# 1984 - 1985 Corvette: Service Bulletin: Door Ajar Switch Corrosion

**Bulletin Number:** 85-43, Number 8B (XII) & 10(I)

**Date:** Feb., 1985

- REPLACEMENT 14087681 DOOR AJAR SWITCH  
(WITH SLEEVE)

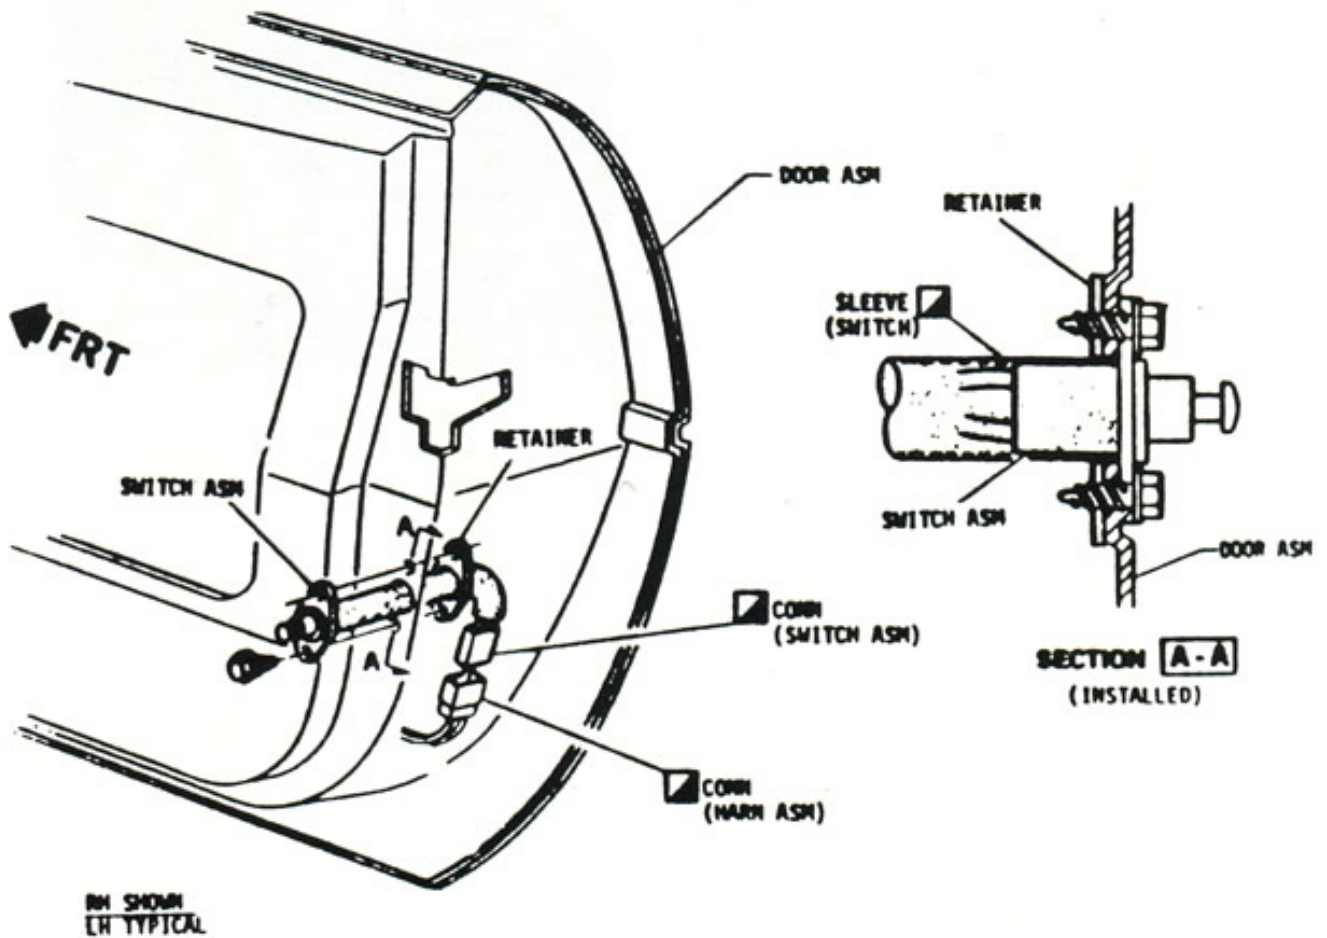
SOME 1984 AND EARLY PRODUCTION 1985 CORVETTE DOOR AJAR SWITCHES (P/N 14062556) MAY BECOME INOPERATIVE DUE TO INTERNAL CORROSION. THIS CAUSES THE DOOR AJAR LIGHT TO EITHER BECOME INOPERATIVE, FLICKER, OR STAY ON.

A NEW CORROSION RESISTANT SWITCH (P/N 14087681) AND AN ASSOCIATED RETAINER (P/N 14087682) ARE TO BE USED AS SERVICE REPLACEMENTS. THE NEW SWITCH INCLUDES A SLEEVE (SEE ILLUSTRATION) THAT FITS TIGHTLY AROUND THE SWITCH'S HOUSING AND HAS SUFFICIENT LENGTH TO COVER THE WIRE CONNECTOR ONCE CONNECTION TO THE DOOR HARNESS IS MADE.

WHEN REPLACING THE EXISTING SWITCH WITH A NEW 14087681 SWITCH, THE DOOR INSERT HOLE WILL NEED TO BE ENLARGED FROM 16MM TO 18MM TO ACCOMMODATE THE SLEEVE PROVISION. CARE MUST BE EXERCISED WHEN ENLARGING THE INSERT HOLE SO THAT ADJOINING MOUNTING HOLES ARE NOT ALTERED. SCRATCHES, CHIPS, ETC., TO DOOR PANEL SURFACE RESULTING FROM THE HOLE ENLARGING PROCESS ARE TO BE COSMETICALLY REPAIRED AS OUTLINED IN SECTION 10 (BODY) OF THE CORVETTE SHOP MANUAL.
